Further Comparison of CDM and FDM

IEEE C80216m-09/1120

IEEE 802.16m Session#61, Cairo, Egypt
Category: AWD comments / Area: Chapter 15.3.9 (UL-CTRL)
“Comments on AWD 15.3.9 (UL-CTRL)”

LLS full loading scenario

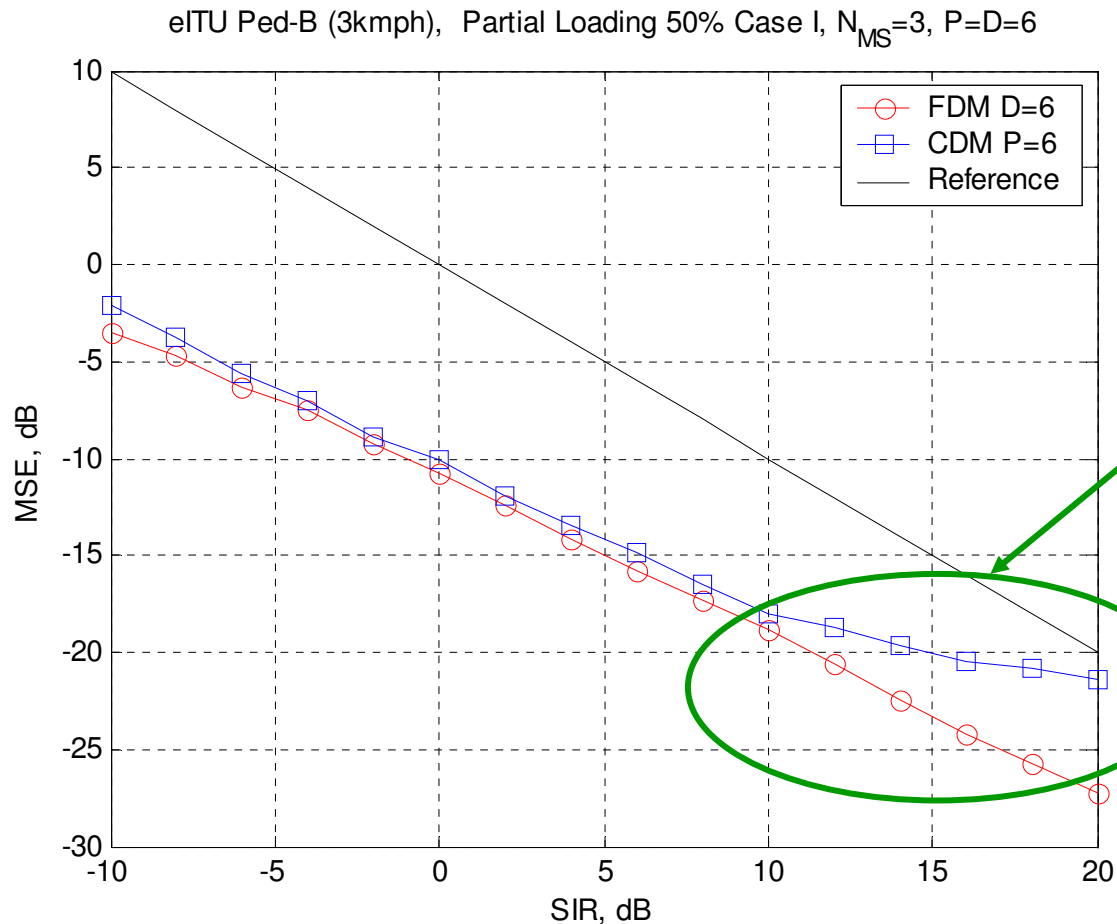
FDM
outperforms
CDM for low
MSE region.
This region is
important for
MU-MIMO
operation

LLS partial loading scenario: 33% (Case II)

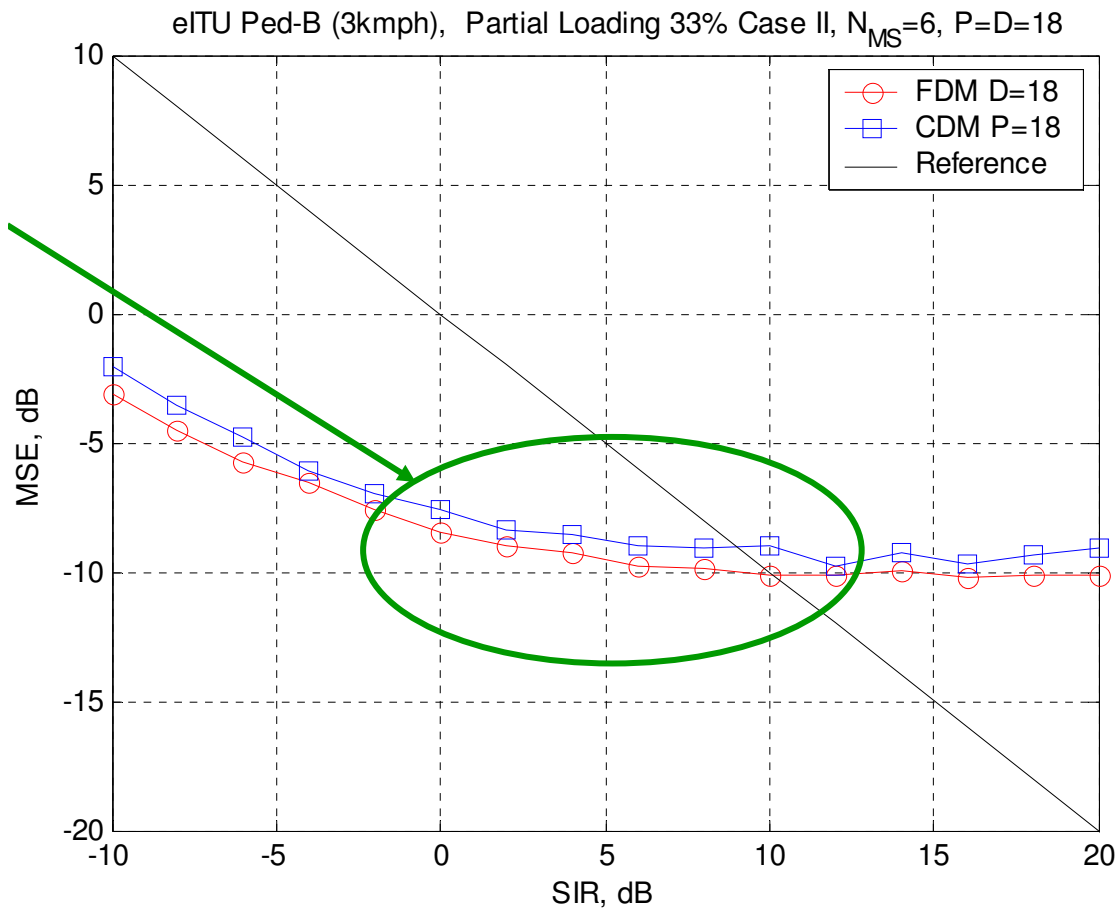
FDM and
CDM shows
similar
performance
for all MSE
range

SLS full loading scenario

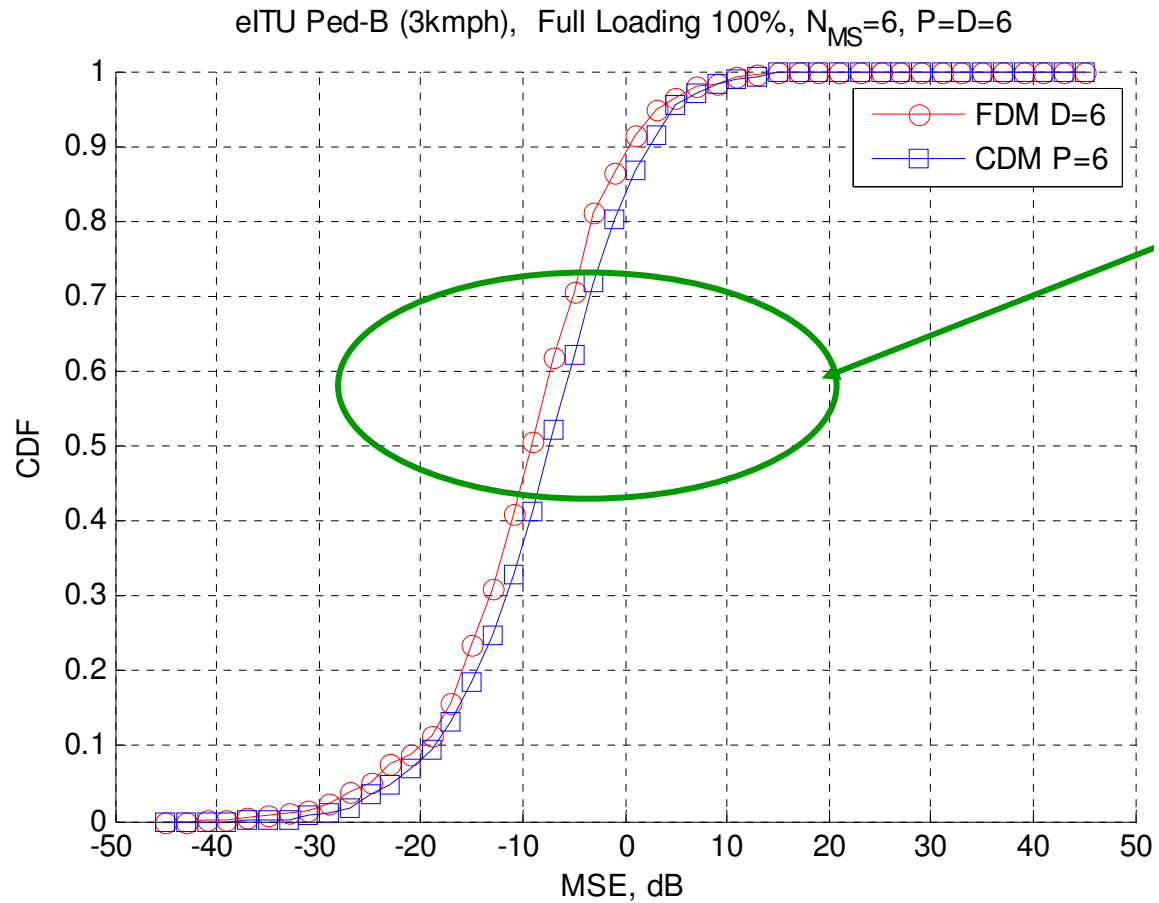
FDM
outperforms
CDM for
almost all
MSE region

eITU Ped-B (3kmph), Partial Loading 50%, $N_{MS}=3$, $P=D=6$

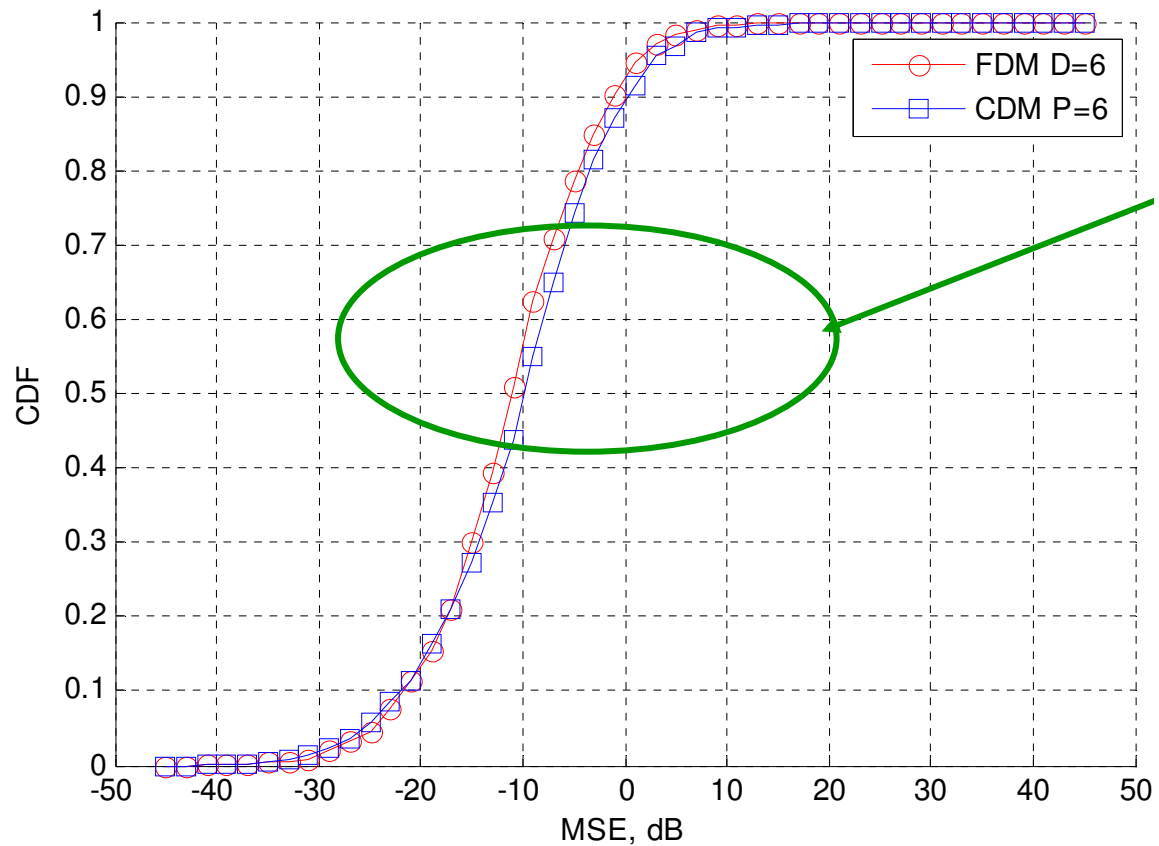
FDM
outperforms
CDM for
almost all
MSE region

SLS partial loading scenario: 33% (Case II)

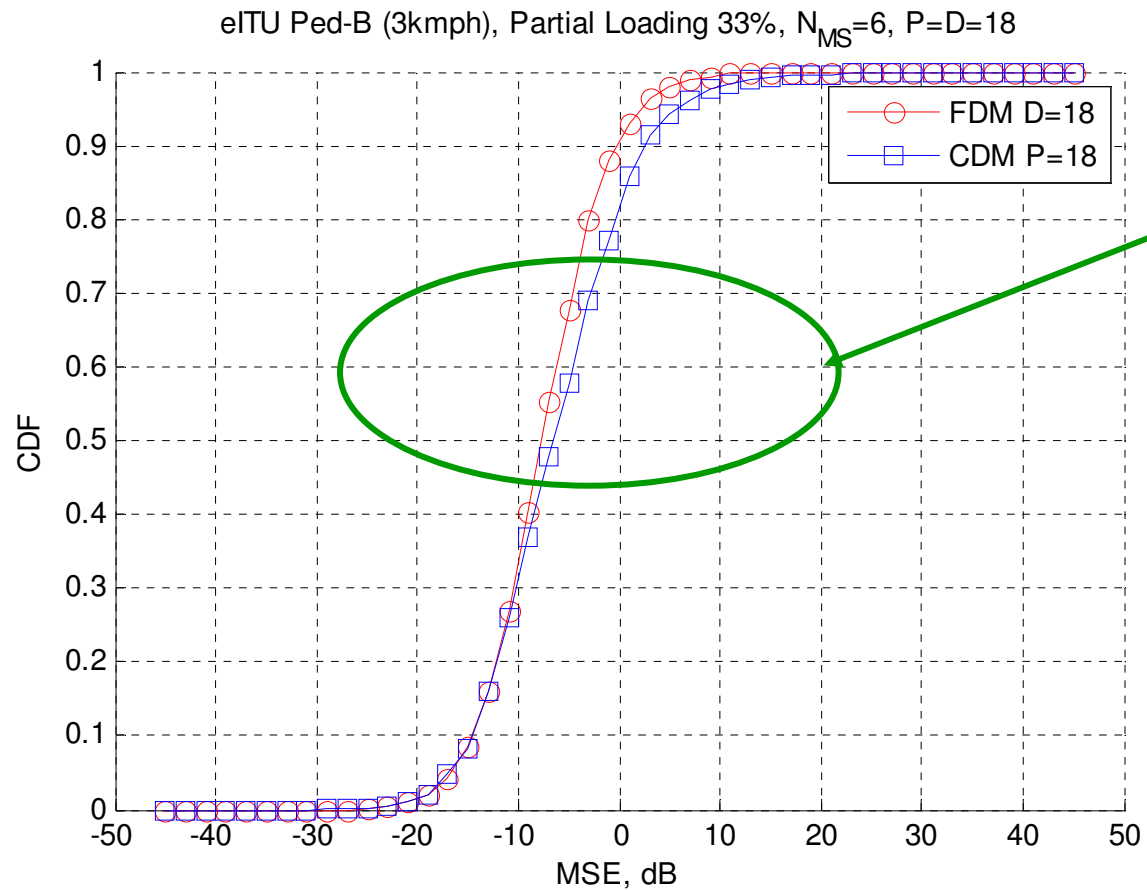
FDM
outperforms
CDM for
almost all
MSE region

CDM with multi-target CINR power control

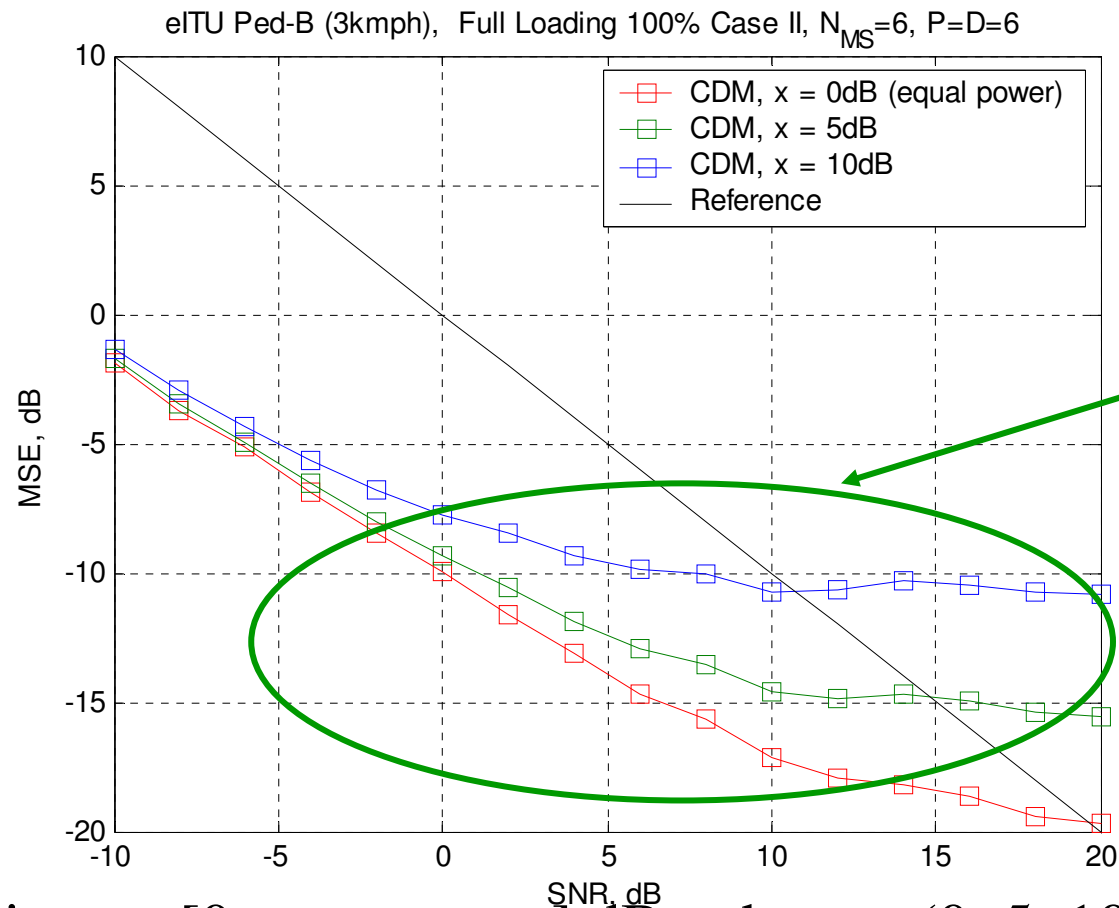
Low power CDM MS is suffering from same sector interference of high power MS in low and medium MSE regions. These regions are important for CL MU-MIMO operation

MS power settings = $[0, x, x, x, x, x]$ dB, where x (0, 5, 10 dB) is relative received power diff. between analyzed MS and high power MS
